SECTION 00 91 13  
ADDENDA

ADDENDUM: No. 1

ADDENDUM DATE: April 16, 2026

This **ADDENDUM** is issued to institute the included changes and/or deletions to the Plans and Specifications for the **CITY OF JEFFERSON MIDDLE OCONEE PUMP STATION & GRAVITY SEWER** project and hereby becomes a part of said Plans and Specifications.

2-D-1  
 OF  
 31

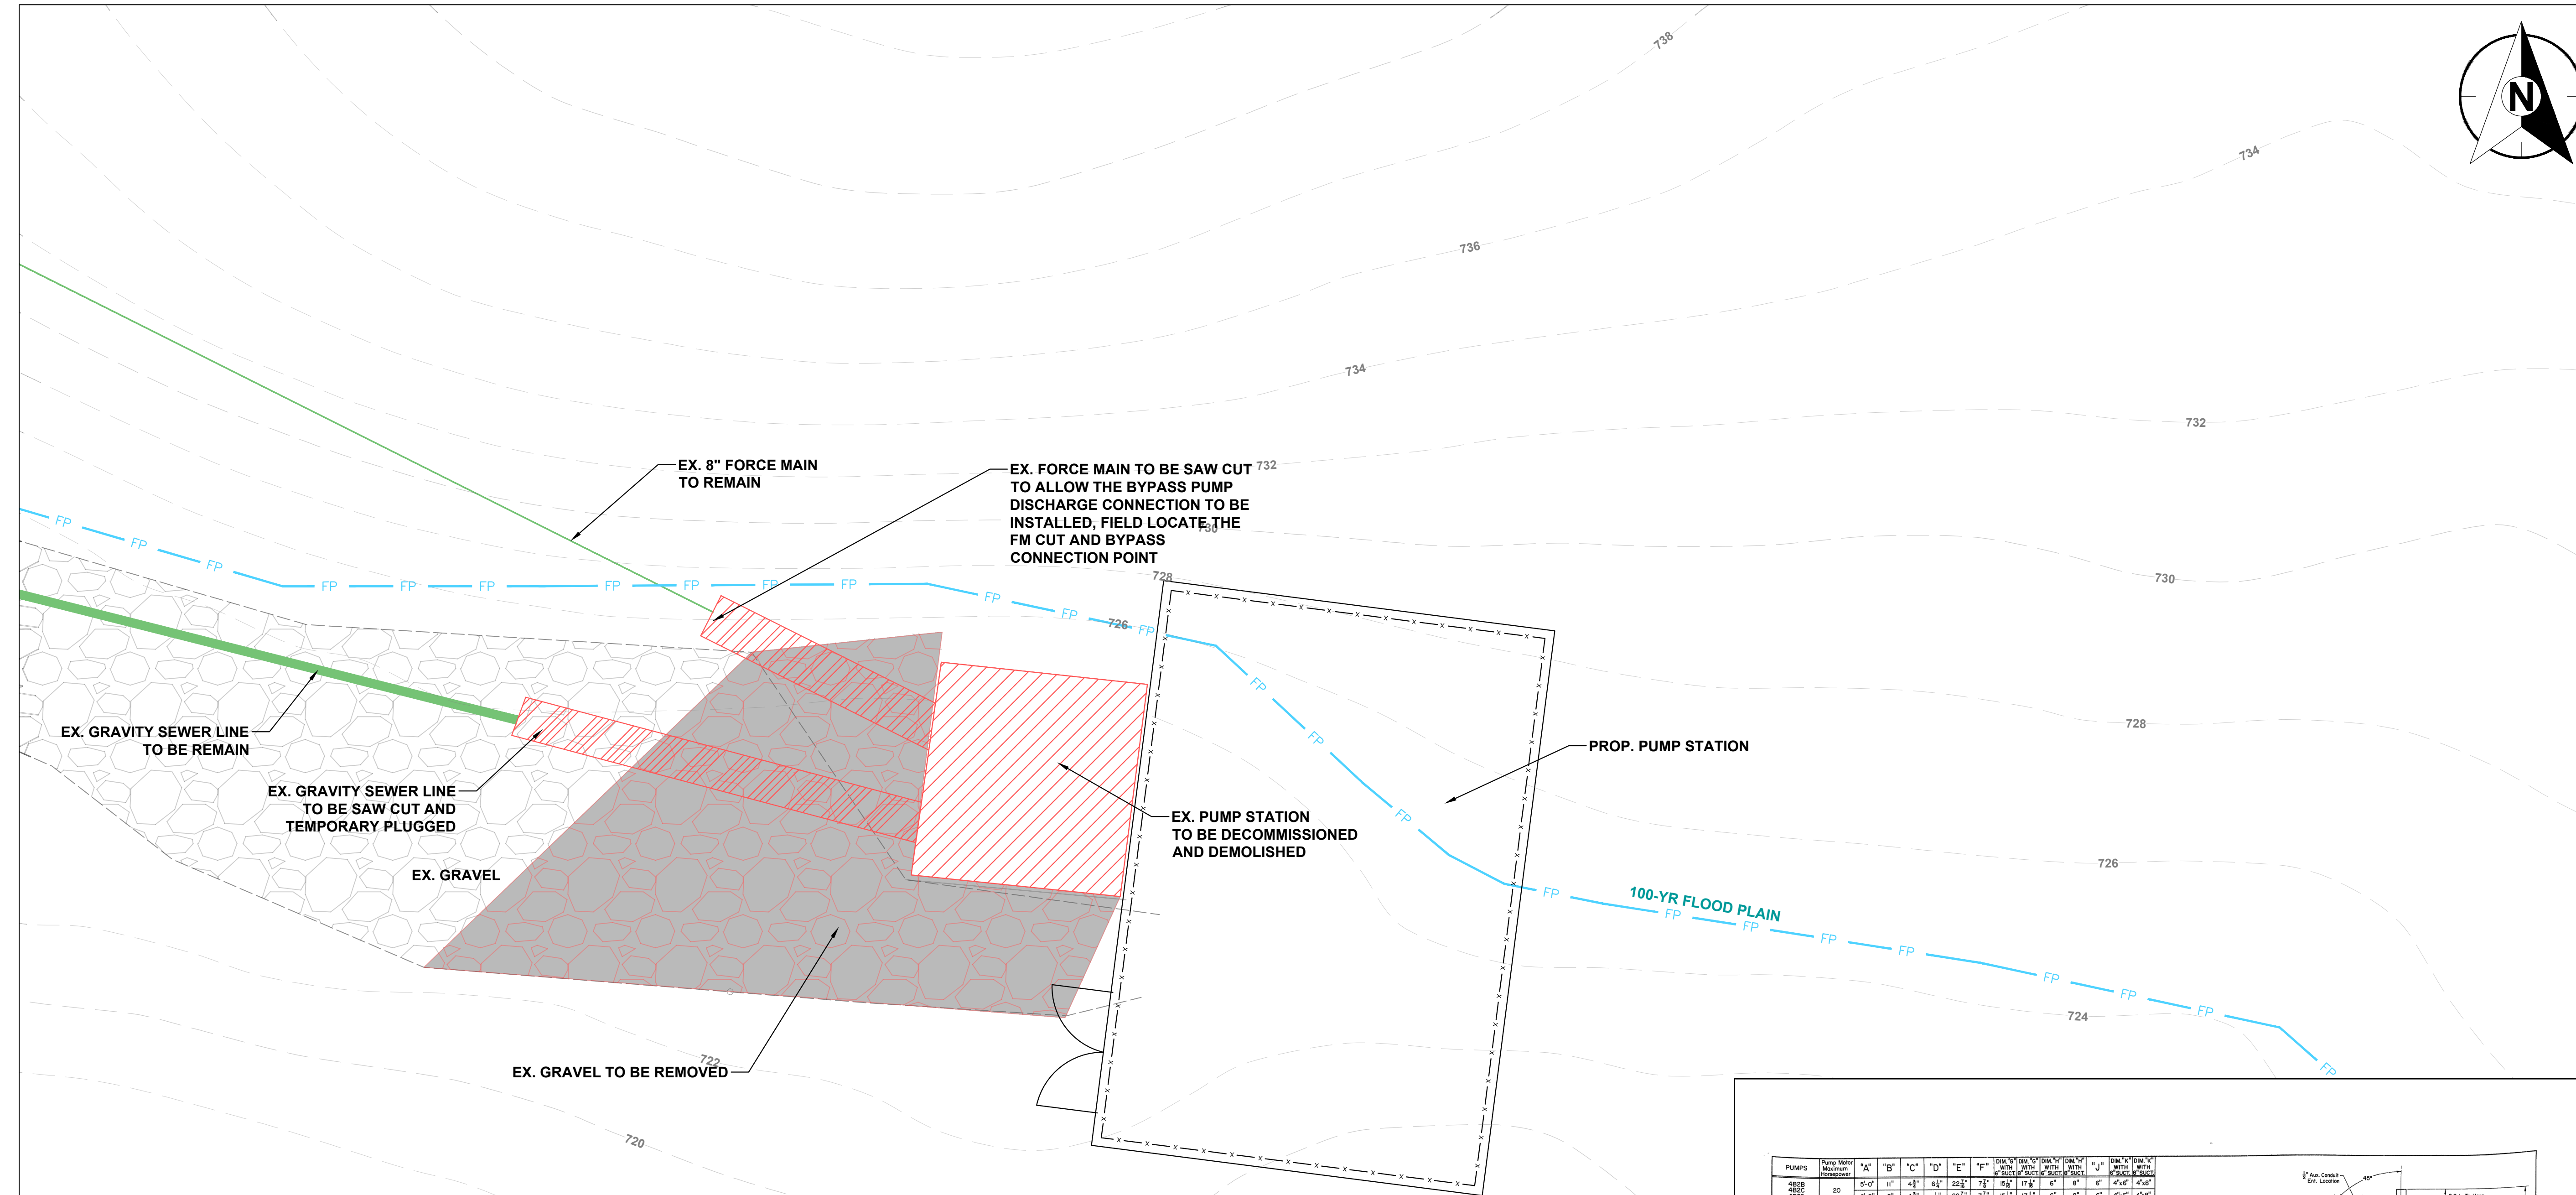
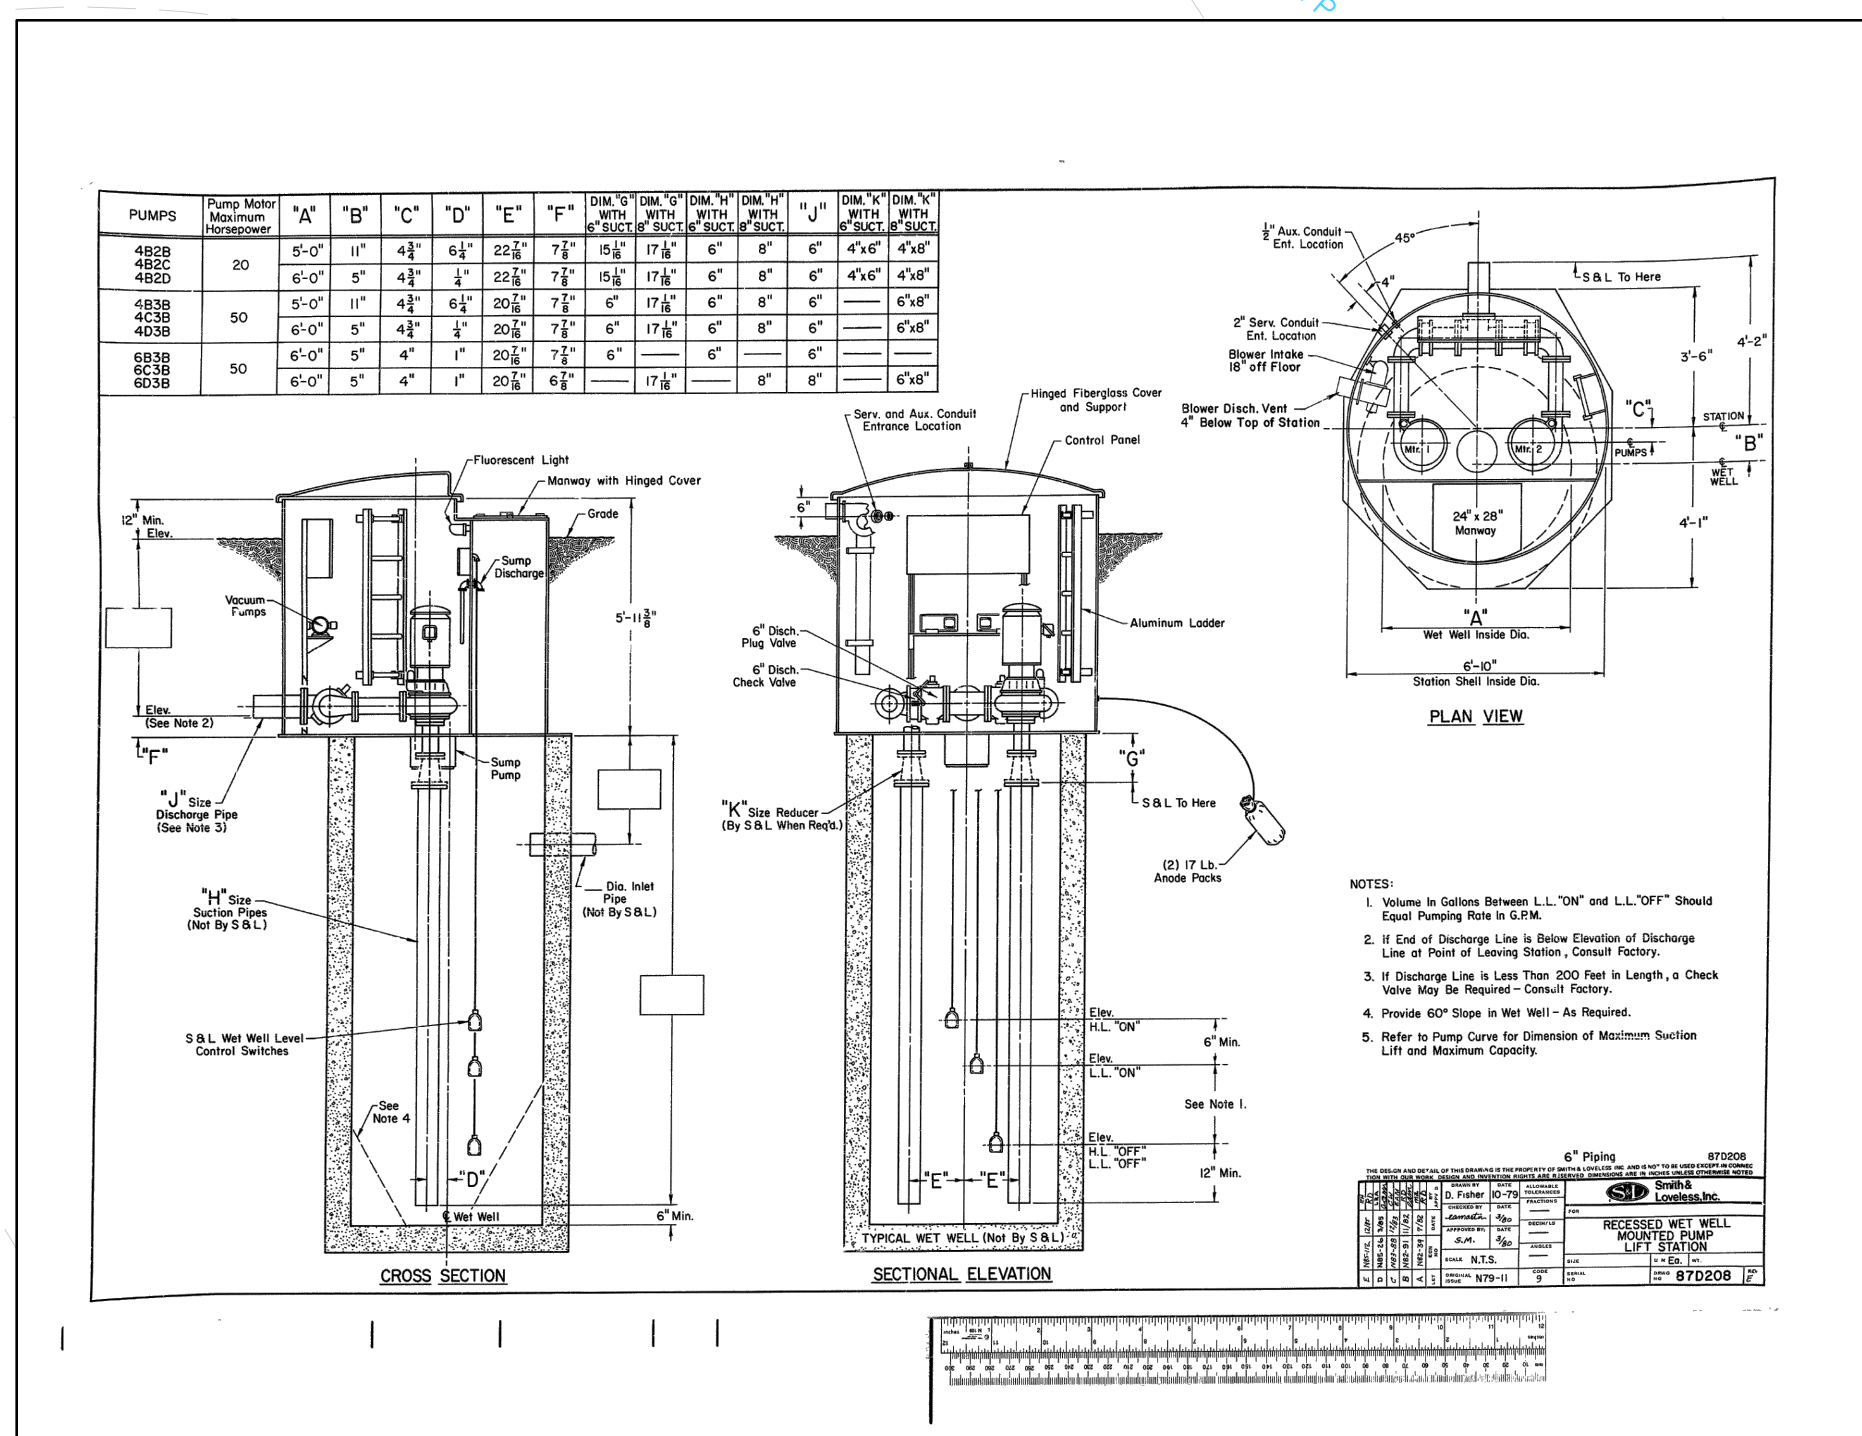
1. Add Modified Detail for Sheet 2-D-1 Demolition Plan. See attached.

21. Will the new PS be able to be built while the old one is running? The only drawing I see shows them on top of each other which will require 100% bypass while we build the new one.

**Please reference the Demolition Plan on Sheet 2-D-1**

- COORDINATE THE REMOVAL AND REPLACEMENT OF PUMPS WITH DEAN LOVE, CITY OF JEFFERSON, 706-215-3139.
- CITY TO SALVAGE THE PUMPS, CONTROL PANEL, AND FIBERGLASS ENCLOSURE. CONTRACTOR TO DELIVER AND UNLOAD EQUIPMENT AT A LOCATION ON SITE DESIGNATED BY THE OWNER.
- TEMPORARY BYPASS PUMPING WILL BE REQUIRED TO REMOVE AND INSTALL THE NEW SUBMERSIBLE PUMP. CONTRACTOR TO PROVIDE ALL PUMPING EQUIPMENTS NECESSARY TEMPORARY PIPING AND CONNECTIONS. CONTRACTOR TO SUBMIT BYPASS PUMPING WORK PLAN TO ENGINEER FOR APPROVAL 14 DAYS PRIOR TO COMMENCEMENT OF WORK.
- CONTRACTOR TO PROVIDE SITE DEWATERING AS REQUIRED DURING SITE CONSTRUCTION

EX. PUMP STATION TO BE DECOMMISSIONED DETAIL
